SIB 64 01 26

RECALL 26V-096: CHECK AND REROUTE COCKPIT WIRING HARNESS

SIB 64 02 26

RECALL 26V-096: CHECK AND REROUTE COCKPIT WIRING HARNESS

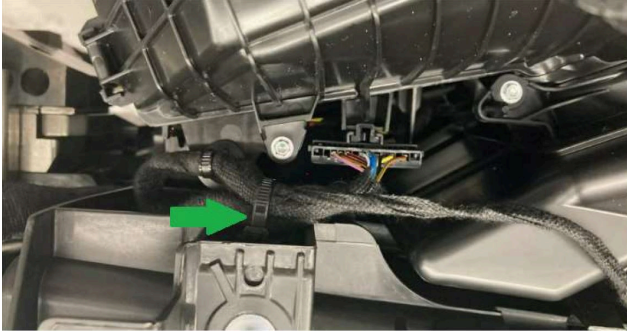
When servicing the cabin air microparticle nanofilter, it is possible to pinch and thereby damage the vehicle's wiring harness while re-installing the retaining screws for the cabin air nanofilter's plastic cover.

Use caution when re-installing the plastic cover for the cabin air filter to ensure no damage is done to the vehicle's wiring harness.

Inspect the harness routing, and add a retainer to the harness (arrow) to prevent it being pinched under the air filter plastic cover.

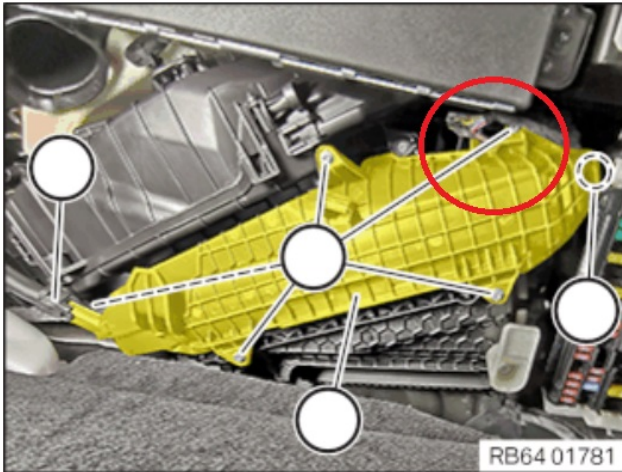
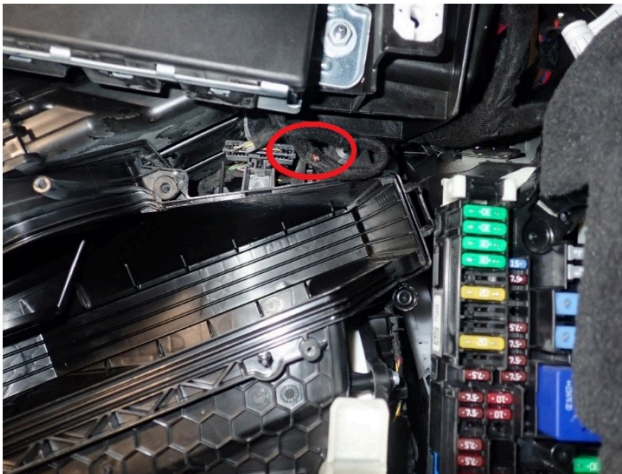
Check the vehicle wiring harness routing (circled) to ensure it is not pinched by the plastic cover over the filter.

This is where the harness can be damaged when installing the cabin air filter cover screw.

This shows the harness damage; the sheathing has been abraded.

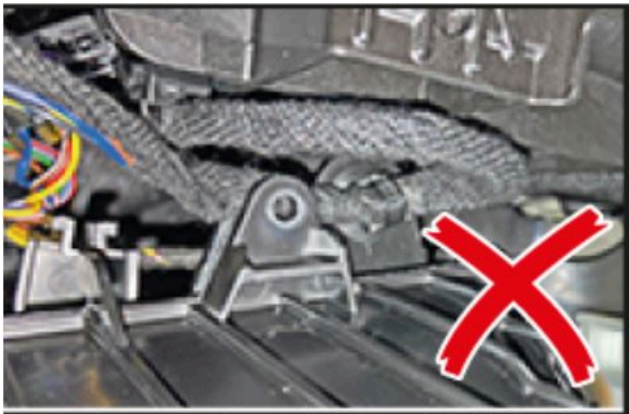
With the harness pulled out of the way, you can see the screw mounting hole for the cabin air filter cover.

Double check the routing of the harness prior to installing the screws for the cabin air filter cover.

The upper photo has the harness visible through the mounting hole. This positioning is not acceptable- the harness must be moved out of the way of the mounting screw.

The lower photo shows the harness positioned in front of the mounting screw, which is an acceptable routing.

If the wiring harness has already been damaged during the installation of the cabin air filter cover, the damaged section of the wiring harness must be repaired.

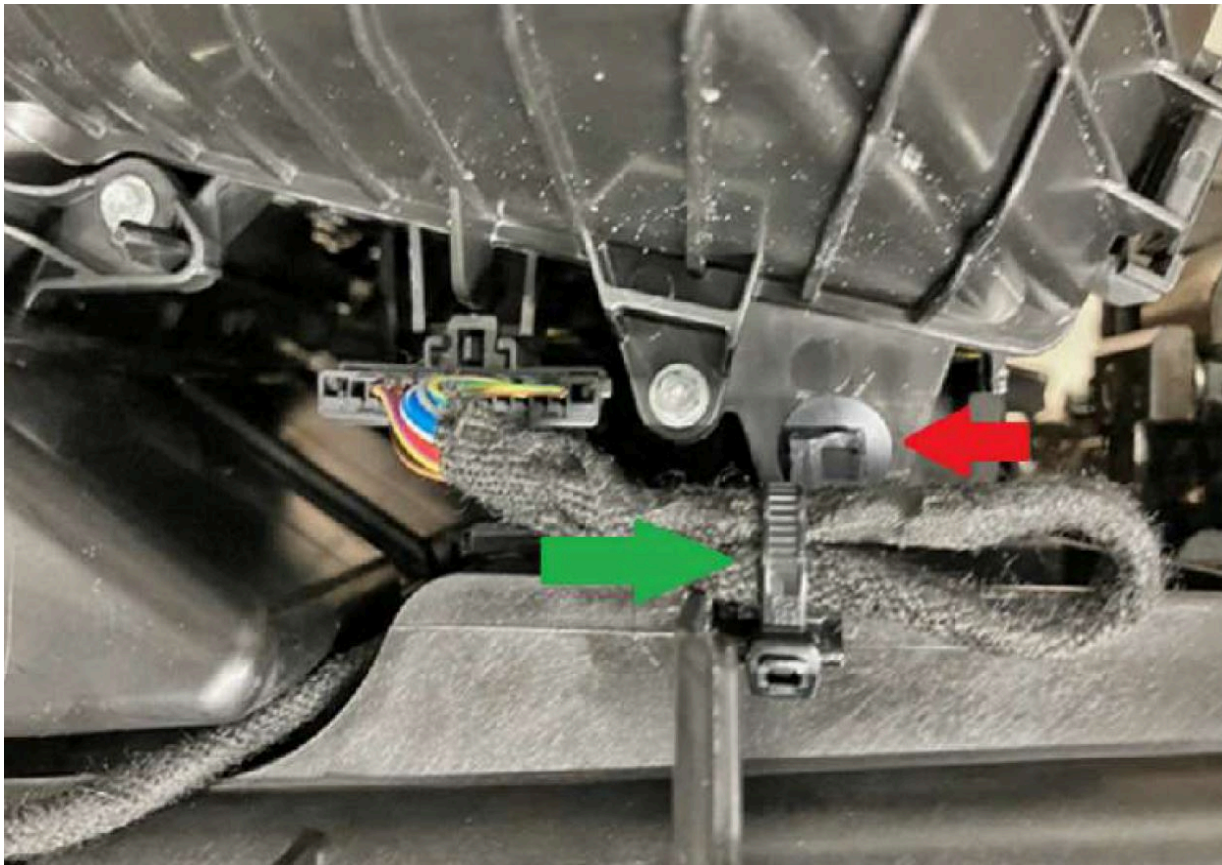
The original harness retainer must be disconnected. This is shown by the red arrow below. It can be left clipped into vehicle but must be disconnected from harness for strain relief.

Install a new harness retainer with cable strap on the instrument panel wiring harness, see green arrow.

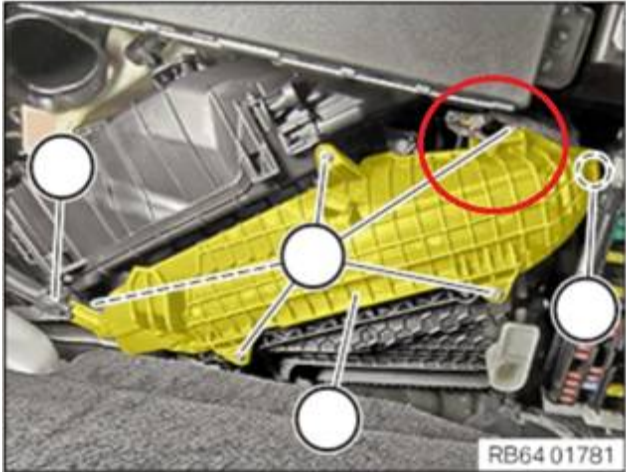
Perform a vehicle test and check if there are any air temperature sensor faults in the BCP module.

Use caution when re-installing the plastic cover for the cabin air filter to ensure no damage is done to the vehicle's wiring harness.

Inspect the harness routing and add a retainer to the harness (arrow) to prevent it being pinched under the air filter plastic cover.

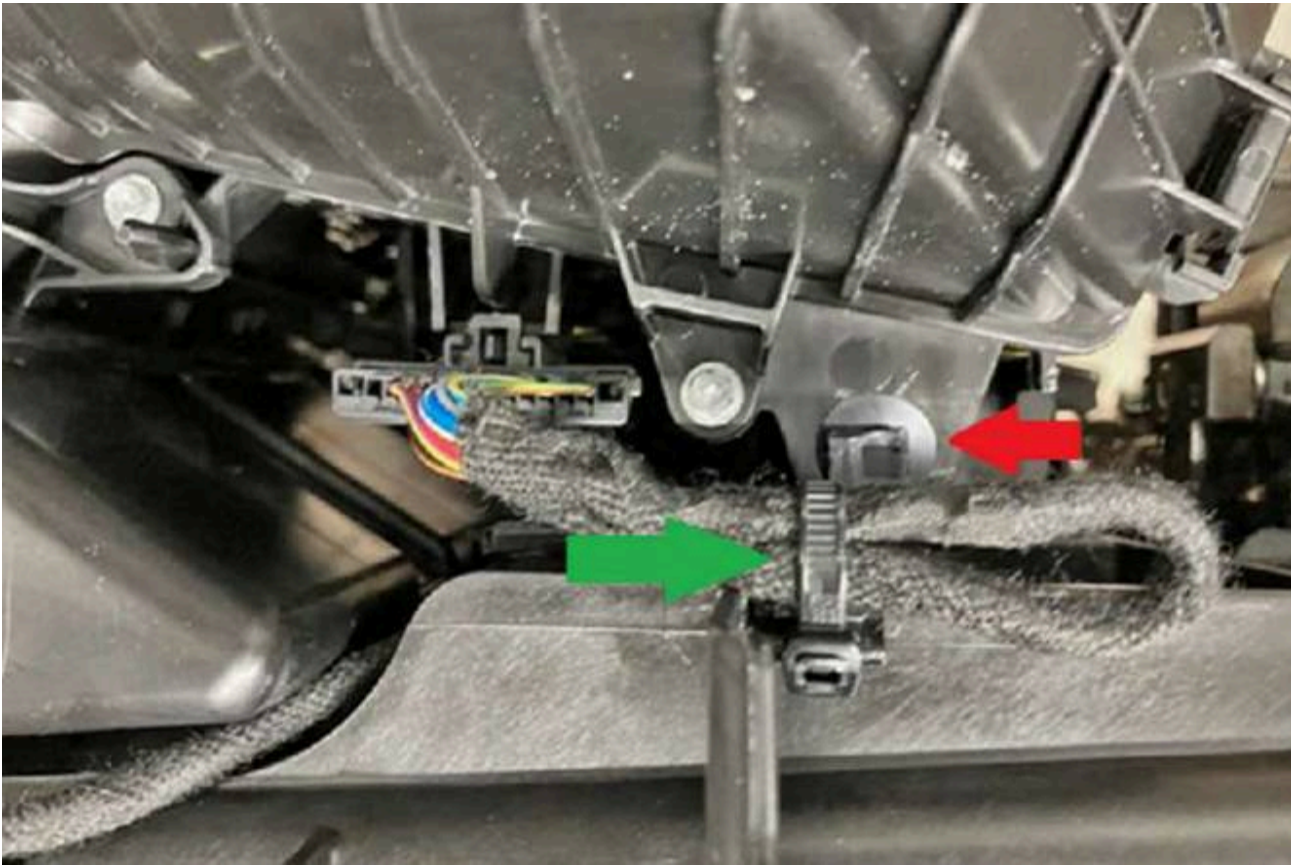
The original harness retainer must be disconnected. This is shown by the red arrow below. It can be left clipped into vehicle but must be disconnected from harness for strain relief. Install a new harness retainer with cable strap on the instrument panel wiring harness, see green arrow.
